PLANNING COMMISSION REGULAR DOCKET TUESDAY, February 12, 2019 at 5:30 P.M. CITY COUNCIL CHAMBERS

PLANNING COMMISSION REGULAR DOCKET
January 8, 2019 – 5:30 P.M.
CITY COUNCIL CHAMBERS
NDS Conference Room

CITY OF CHARLOTTESVILLE
DEPARTMENT OF NEIGHBORHOOD DEVELOPMENT SERVICES
STAFF REPORT TO THE ENTRANCE CORRIDOR REVIEW BOARD (ERB)

ENTRANCE CORRIDOR (EC)
Request to Amend the May 8, 2018 Certificate of Appropriateness

1 NORTH ELEVATION
 1" = 10'-0"

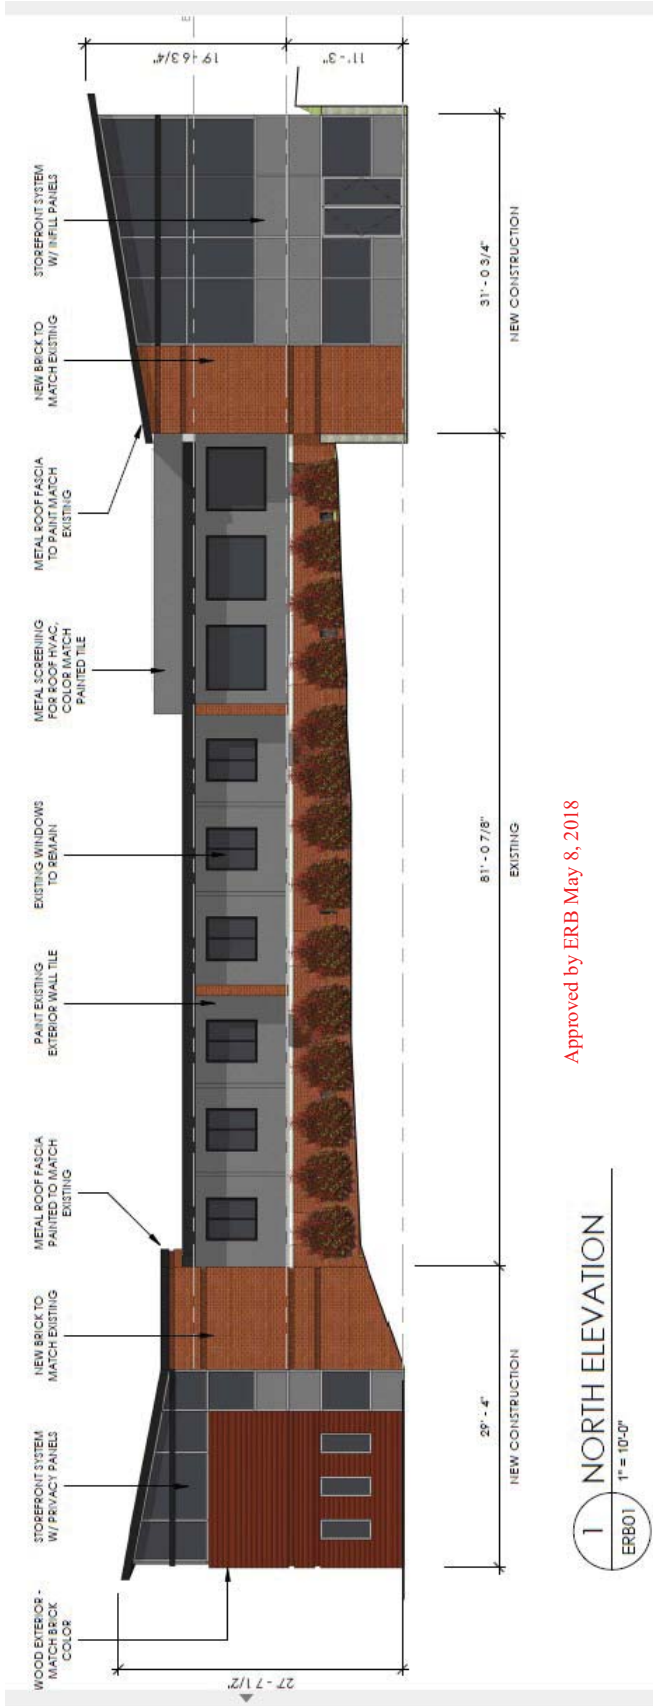
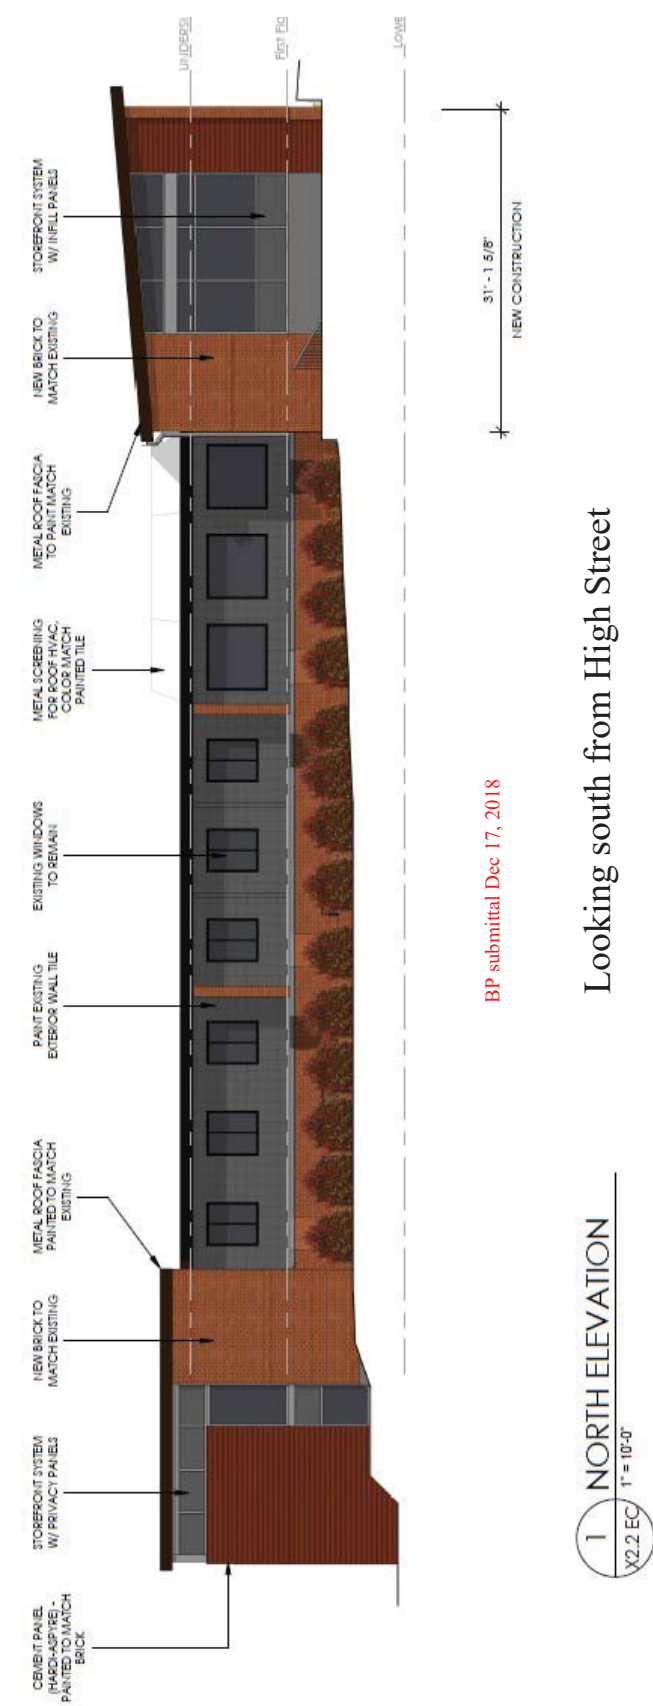
No brick changes from approved.
 Color is not different.

1 SOUTH ELEVATION
 ERB02
 1" = 10'-0"

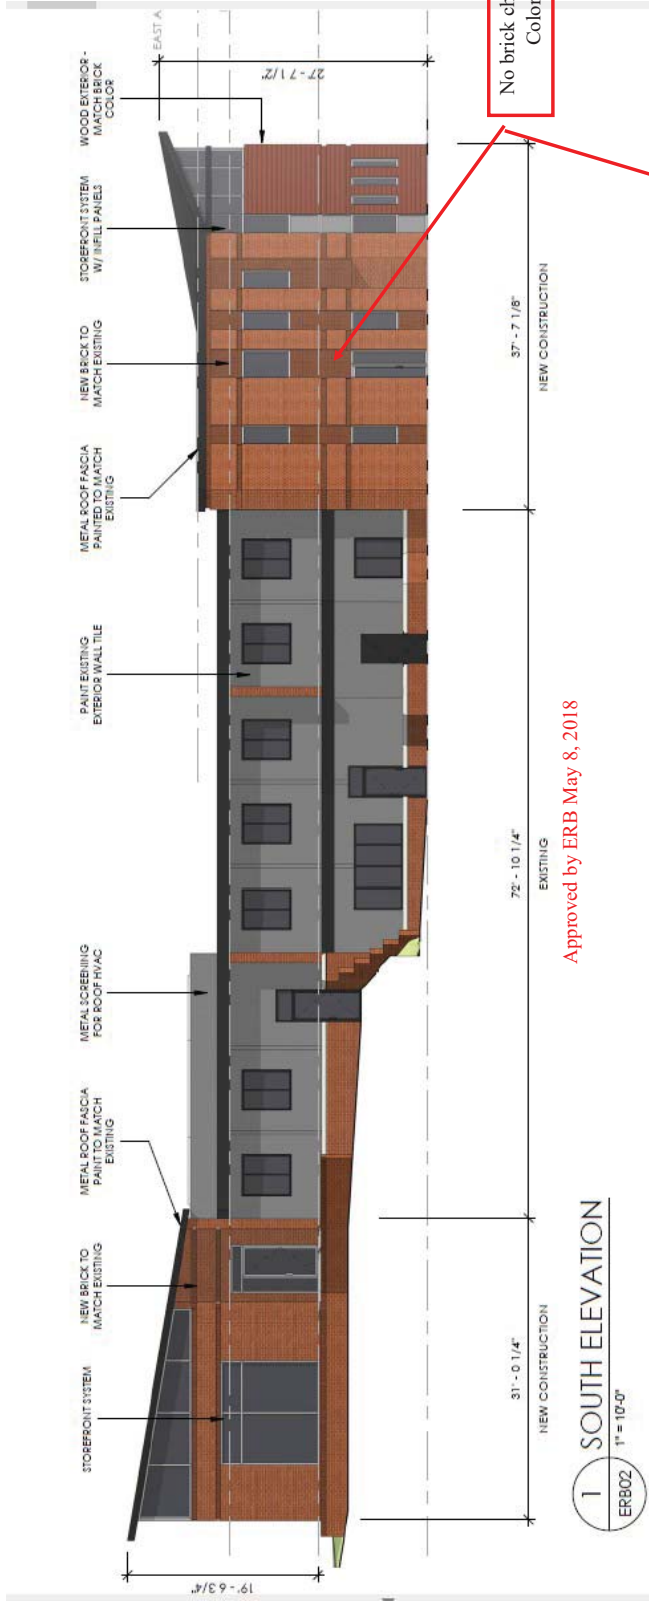
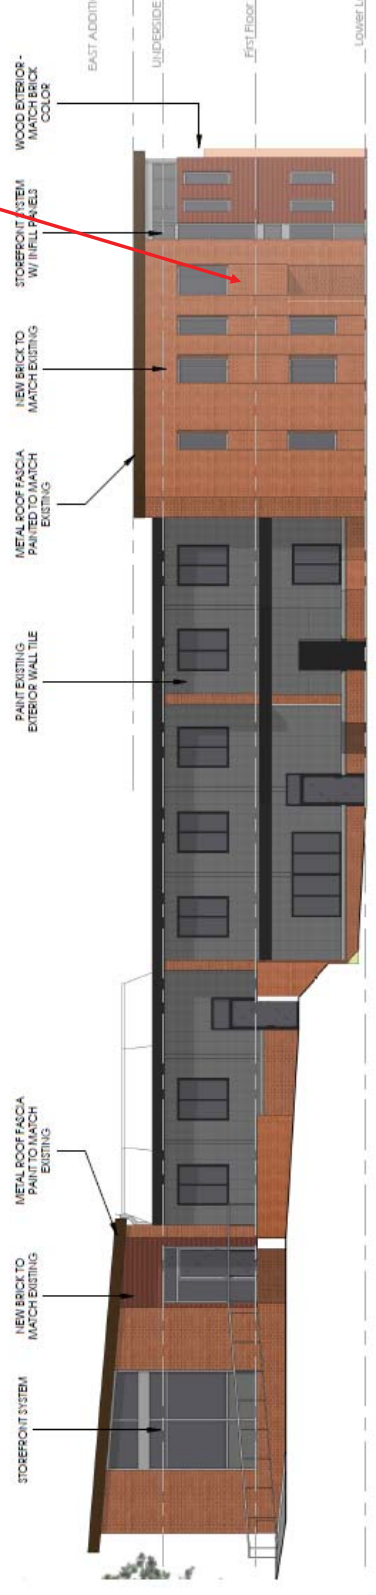
No brick changes from approved.
 Color is not different.

City Critical Slopes Compared with Applicant Critical Slopes

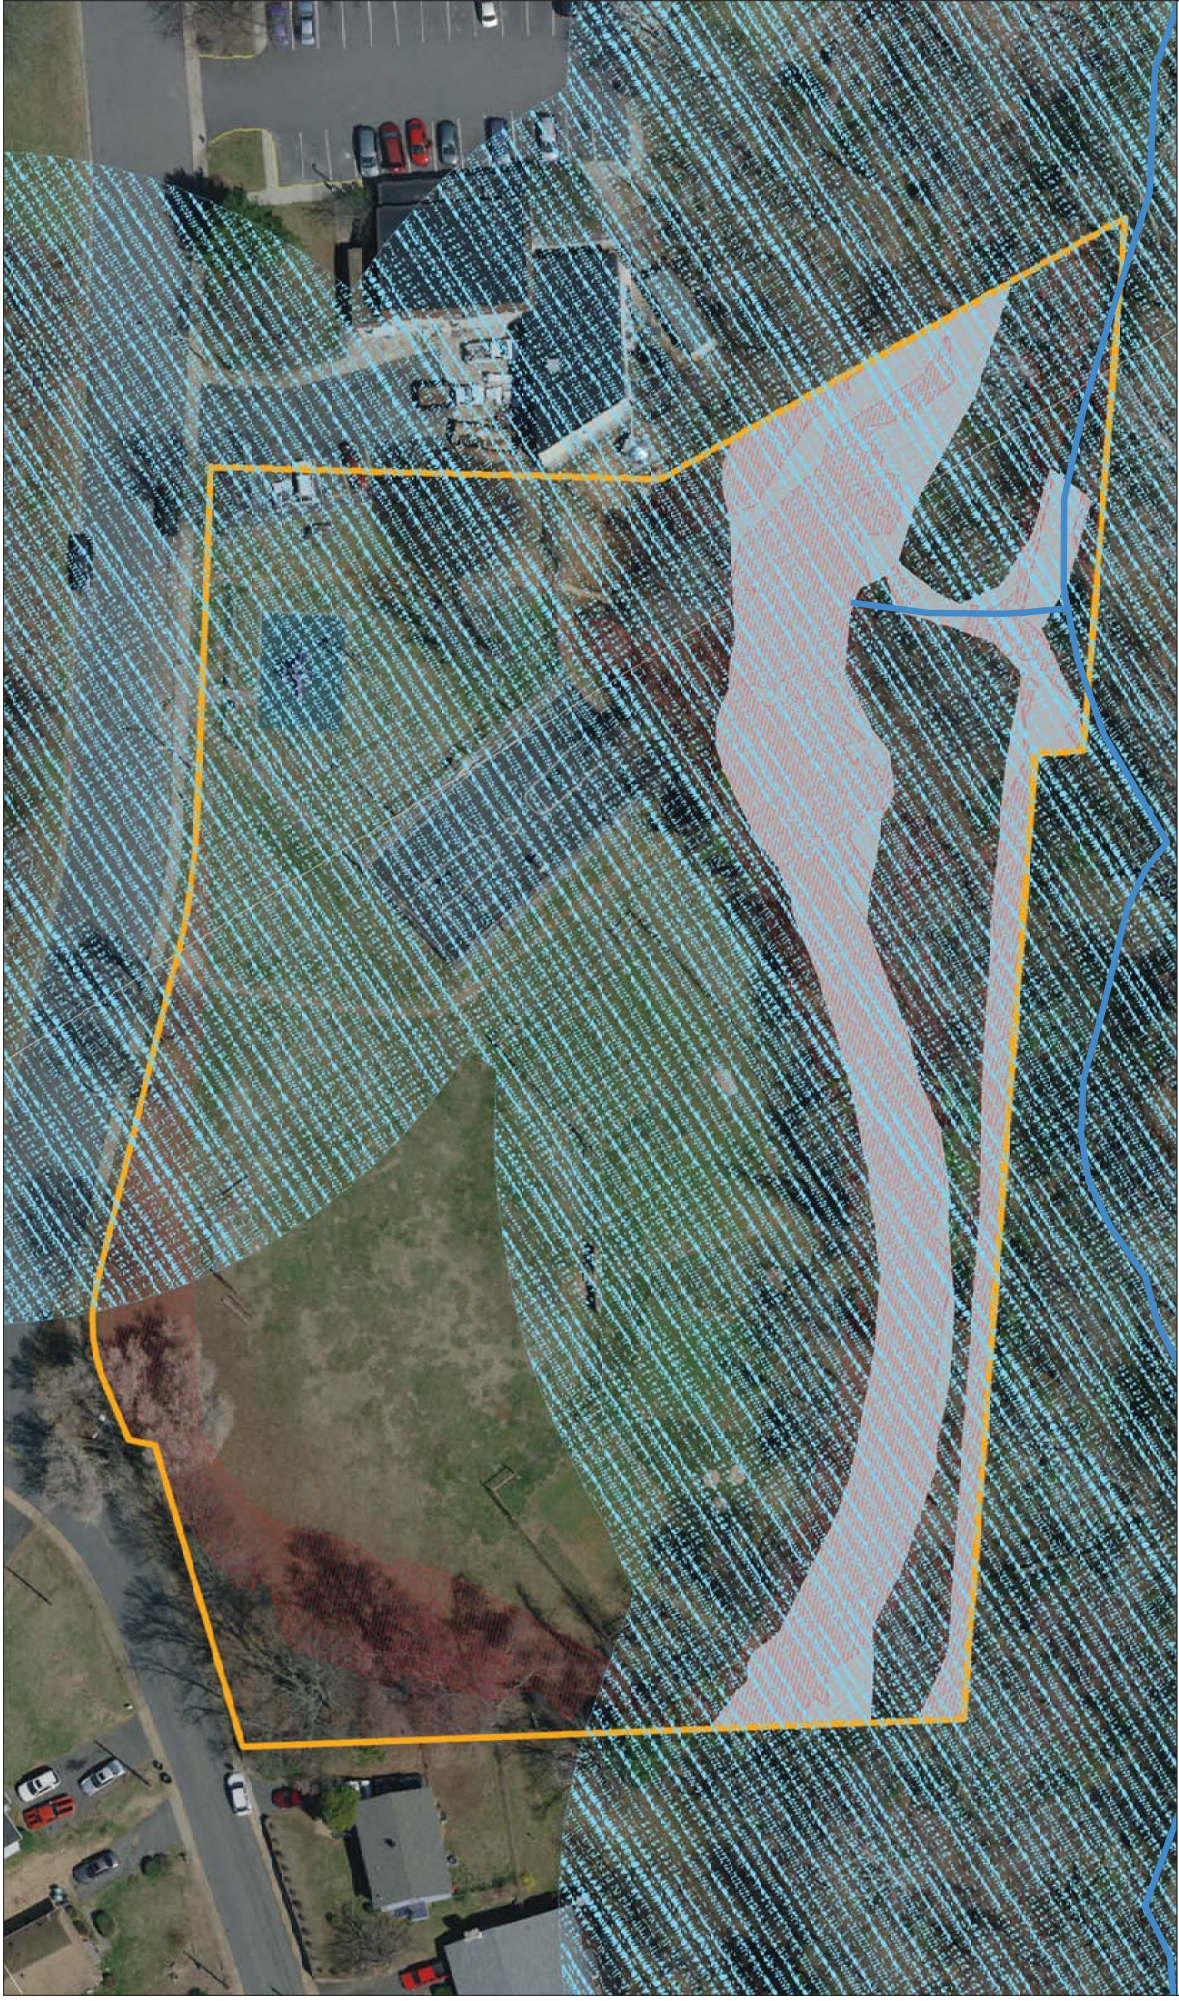
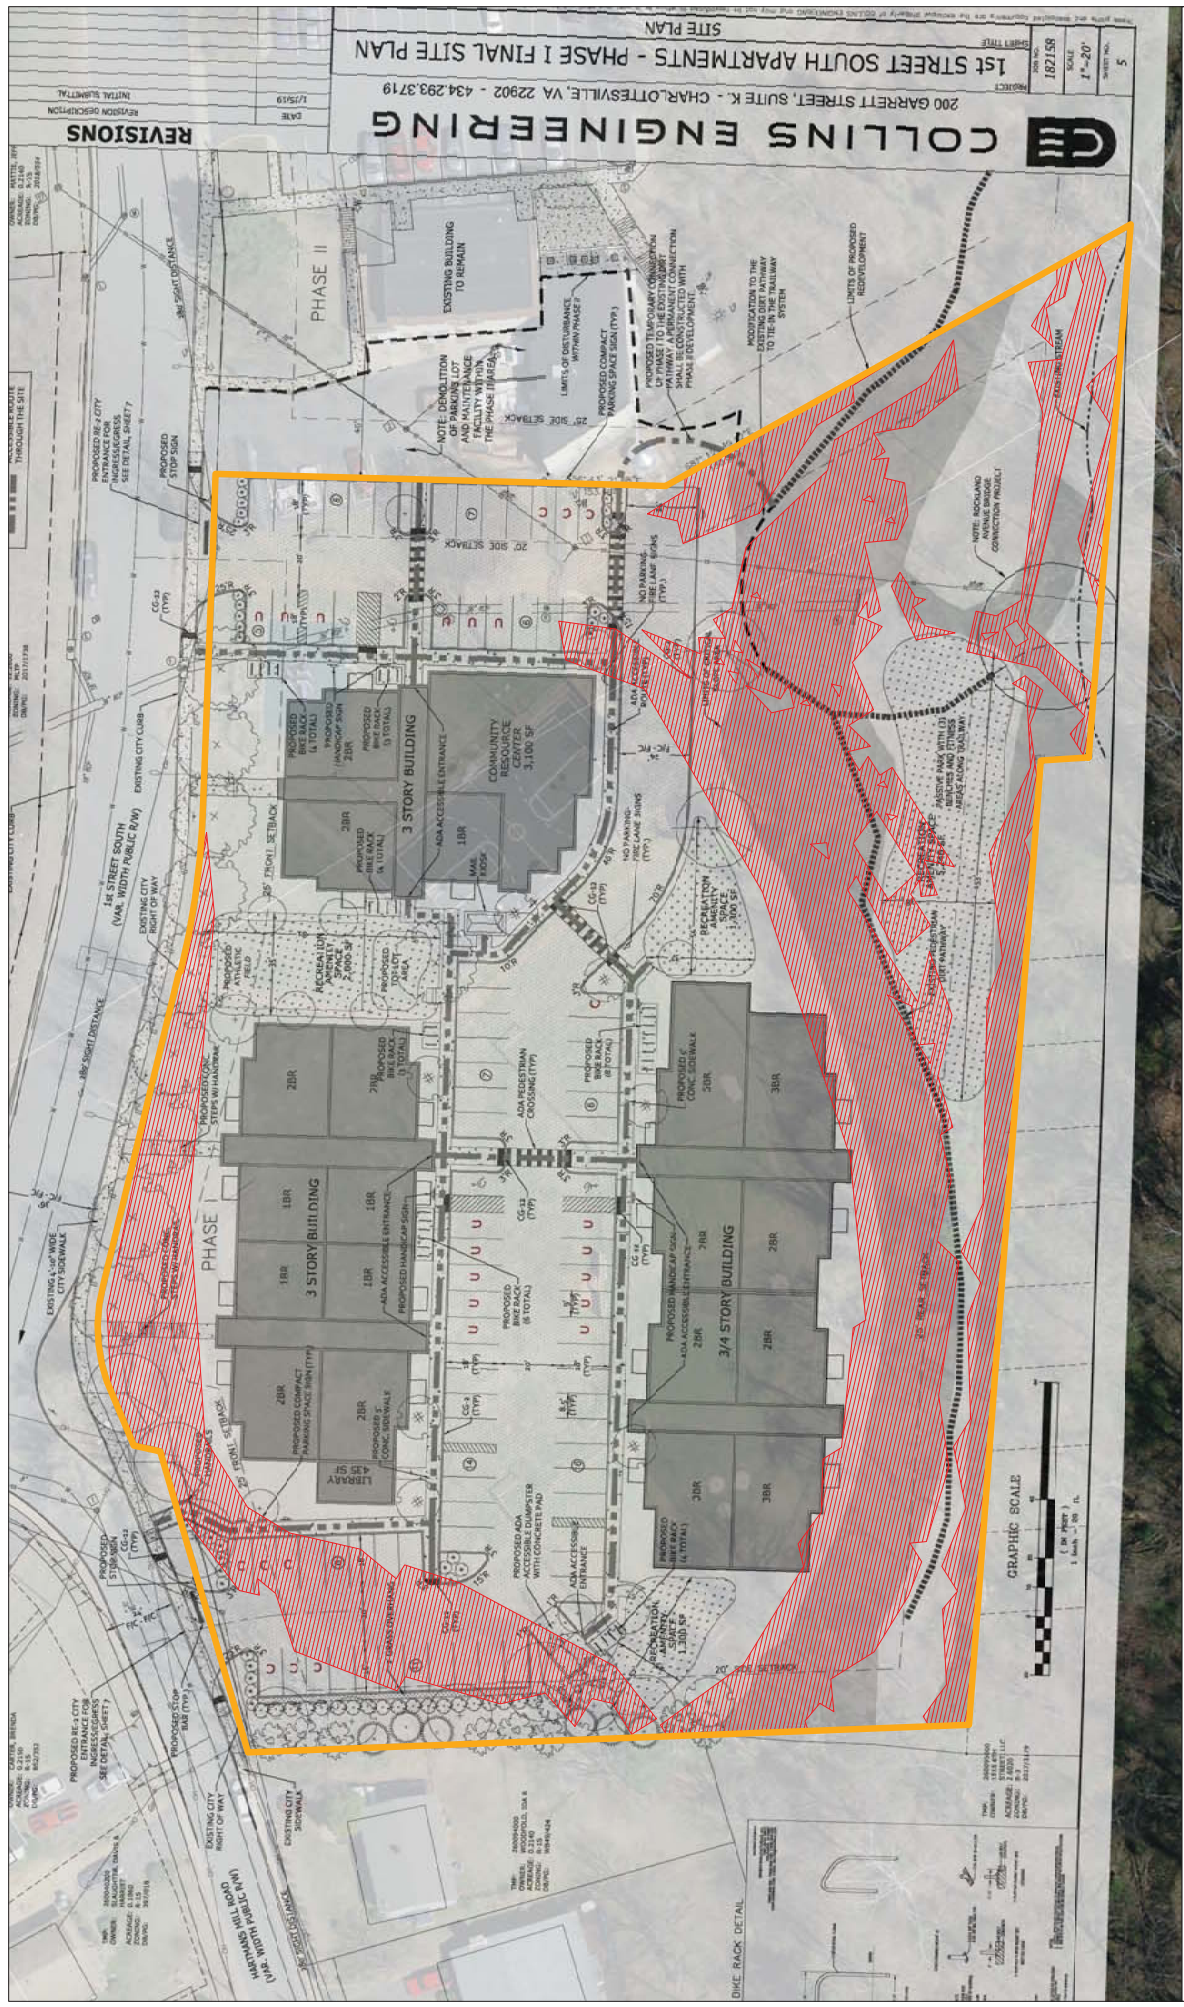
2. The applicant states in their Critical Slopes Waiver Request that "Areas of slope that are adjacent to the property frontage do not qualify as critical slopes because they are more than 200 feet from a waterway". However, the definition of a critical slope in City Code Chapter 34-1120(b)(2)b states that **a portion** of the slope must be within 200 feet of a waterway. In their Final Site Plan submittal, on Sheet 2 the applicant depicts a "200' limit from existing stream", but does not show the extent of the City defined critical slopes at the terminus of this limit, which makes it impossible to determine if those slopes are actually within this 200' limit. Additionally, it doesn't appear that the existing stream (Pollocks Branch) has been surveyed in the vicinity of the start of the "200' limit from existing stream". The portion of Pollocks Branch that has been surveyed by the applicant does not align with the lines representing Pollocks Branch that are used as the start of the "200' limit from existing stream". What is the data source used by the applicant for the spatial location of Pollocks Branch in this area? If the City's GIS data are used for the spatial location of Pollocks Branch, then there are several spots along Pollocks Branch that are within 200' of the slopes in question, which would classify them as critical slopes. When the City critical slopes are overlaid onto the applicant's Final Site Plan Sheet 2, even using the applicant's spatial location of Pollocks Branch, there are other points along Pollocks Branch that appear to be within the applicant's "200' limit from existing stream". If it continues to be the applicant's assertion that these slopes are not critical because they are more than 200' from Pollocks Branch, then additional information regarding the spatial location of Pollocks Branch is needed to verify this claim.

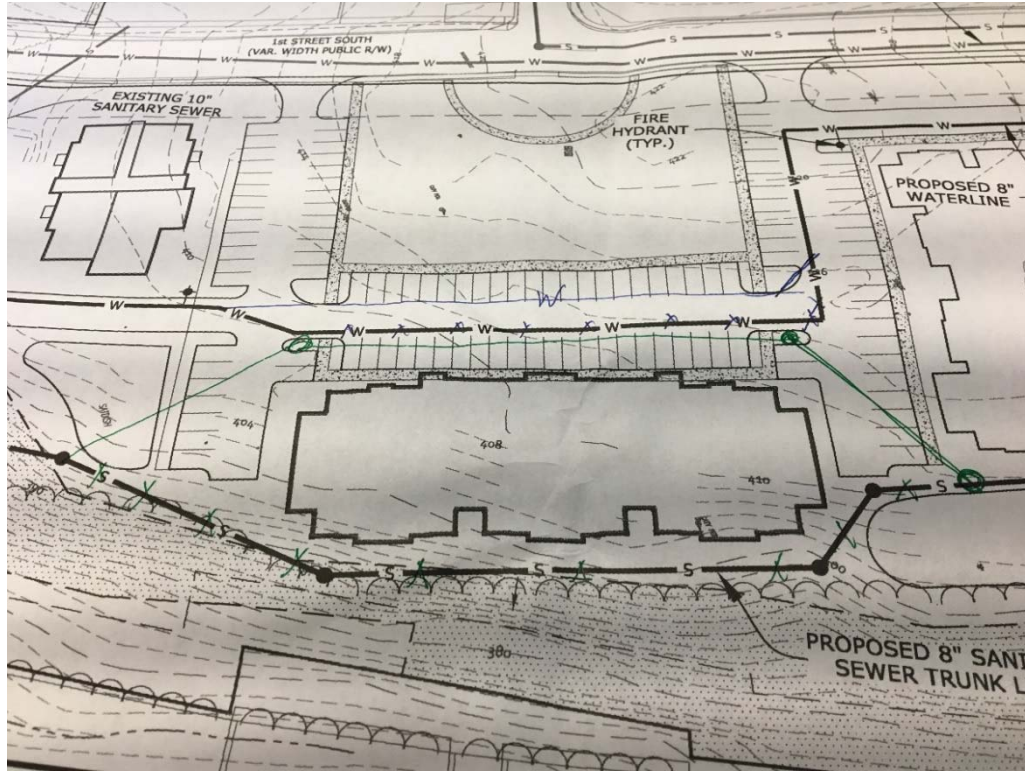
7. On sheet 6, the proposed mail kiosk encroaches in the easement for the new gas line. Please move the kiosk out of this easement.
8. On sheet 21, for the conceptual waterline alignment, please show the new 8-inch line continuing up to Elliot Ave where it connects to the existing 12-inch waterline. This is needed for looping. Below is a photo of this sketched on the plan:

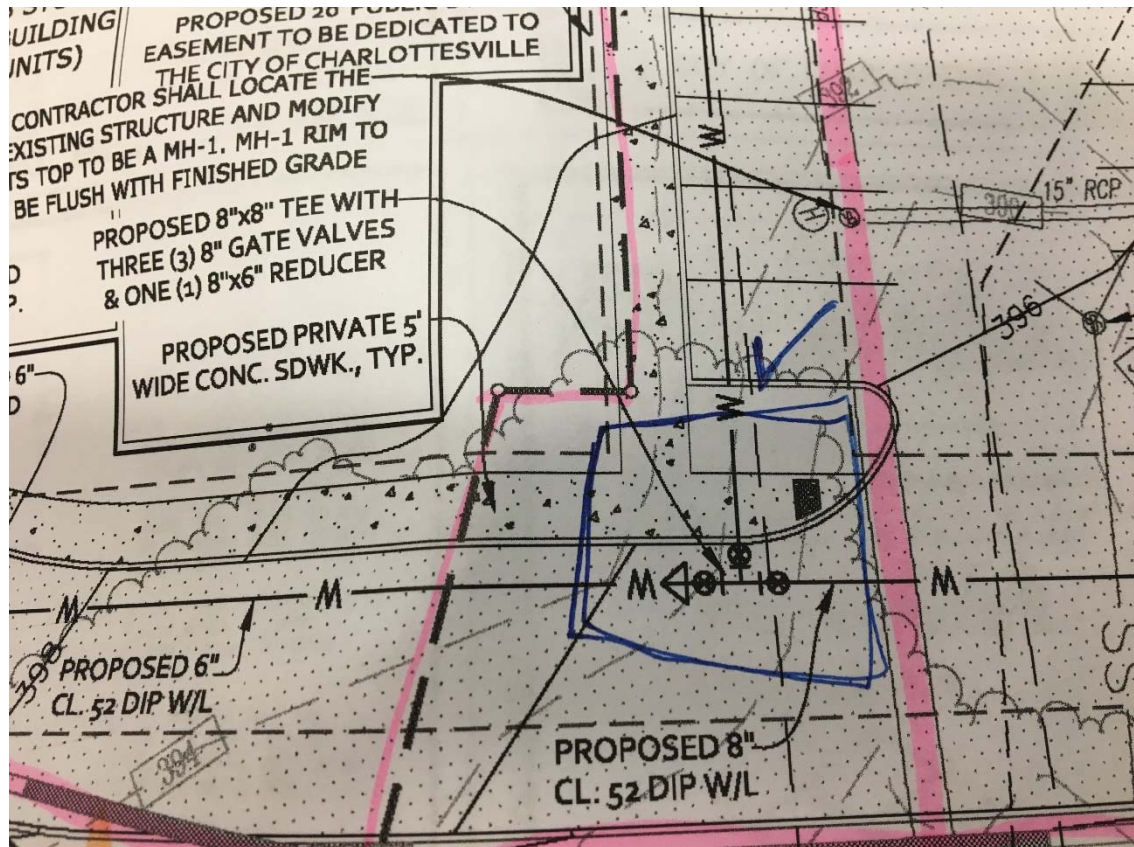
9. On sheet 21, for the conceptual sewer alignment, please show the sewer line running in asphalt in front of the largest building in Phase 2. This will require a shift in proposed waterline location. The sewer may be deeper, but it should be in asphalt at this depth rather than being on slope behind a building. Below is a photo of this sketched on the plan:
